**City of Saint Paul**

**DESIGN VARIANCE REQUEST #1**

**SP 164-020-109  
Minn Proj # TEAX 6212 (276)**

**ROUTE NAME: Raymond Avenue  
FROM: University Avenue/C.S.A.H. 34  
TO: Hampden Avenue**

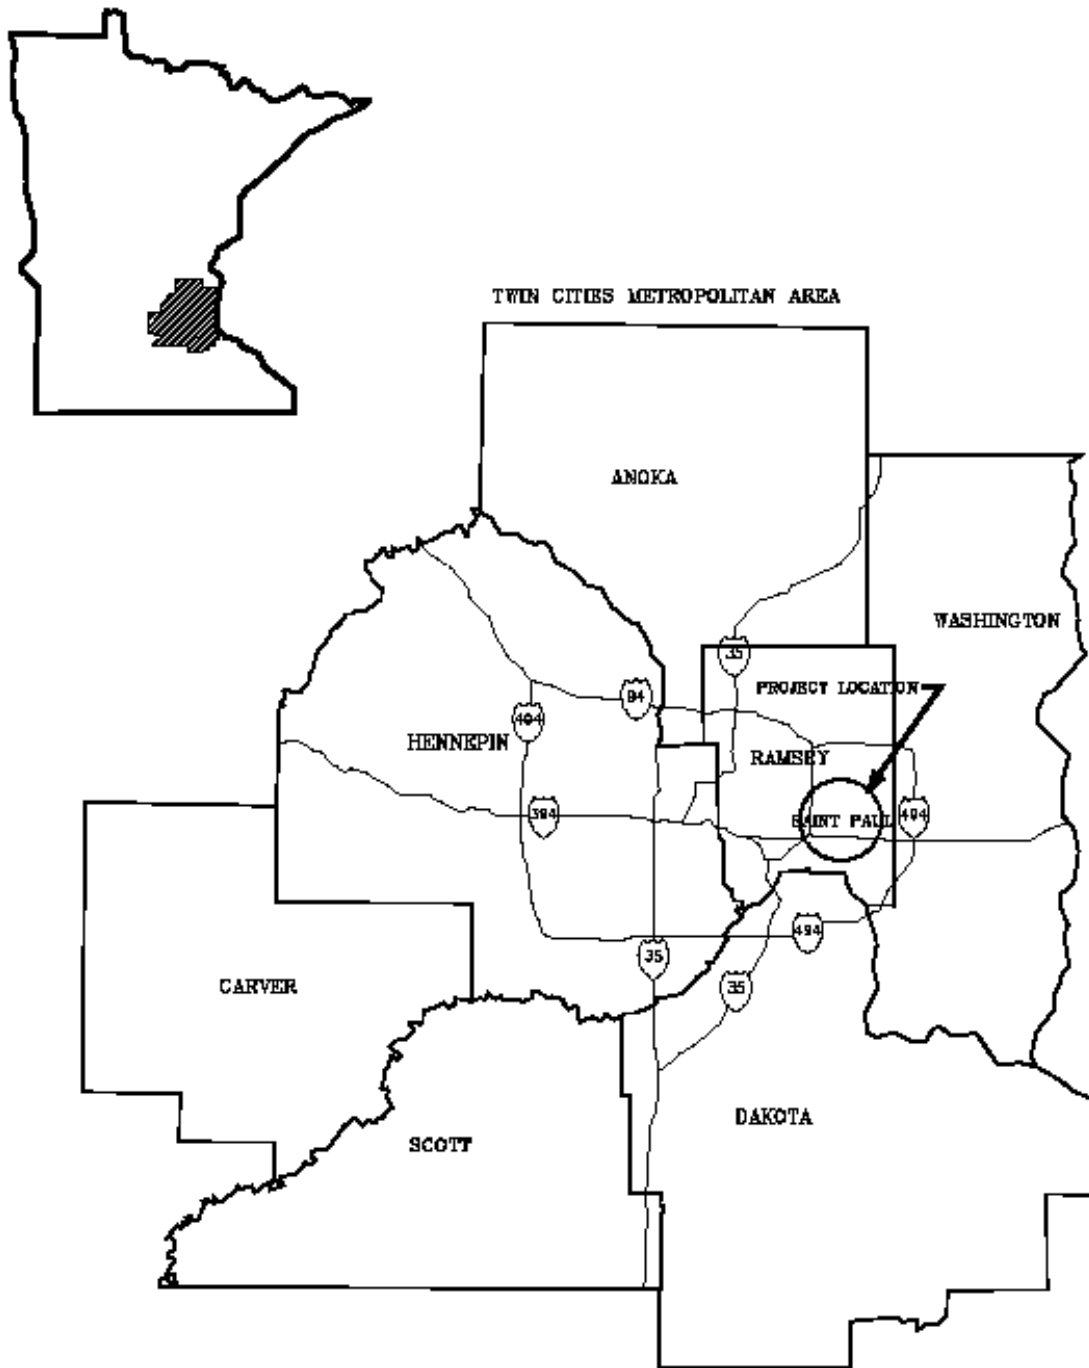
The MnDOT Road Design Manual figure 3-3.02A requires that a roadway with a horizontal curve radius below 280' radius should be superelevated when the design speed is 30 mph.

The City is requesting a variance to construct the curve without superelevation.

The proposed design matches the existing curve radius of 262'. We cannot propose a larger radius because we are constrained by existing right-of-way and existing infrastructure.

In order to meet watershed regulations, we have designed a rain garden adjacent to the curve. It is intuitive to slant the road toward the garden in order to direct surface water to the garden. If the roadway were to be superelevated, surface water would be directed away from the garden. If that side of the roadway were raised, more property would be required for slopes in the garden, thereby decreasing the size and storage capacity of the garden. The reduced storage capacity would not meet watershed regulations.

We are redesigning the alignment of the existing, skewed Bayless/Raymond intersection. The new intersection is near the north end of the curve. Superelevating the curve would force a steeper uphill grade on Bayless Avenue as a vehicle approaches the new intersection with Raymond Avenue.

Design Element Involved: Horizontal Curve

Required Standard: Superelevation  $e_{max} = 0.06/0.06$

Proposed "in lieu of" Design: curve with adverse superelevation.

Degree to which the standard is reduced: a curve radius of 280' is required to avoid the superelevation requirement, the proposed centerline curve radius is 262' The adverse super elevation only affects the south bound lane. The centerline curve radius for the southbound lane is 276'.
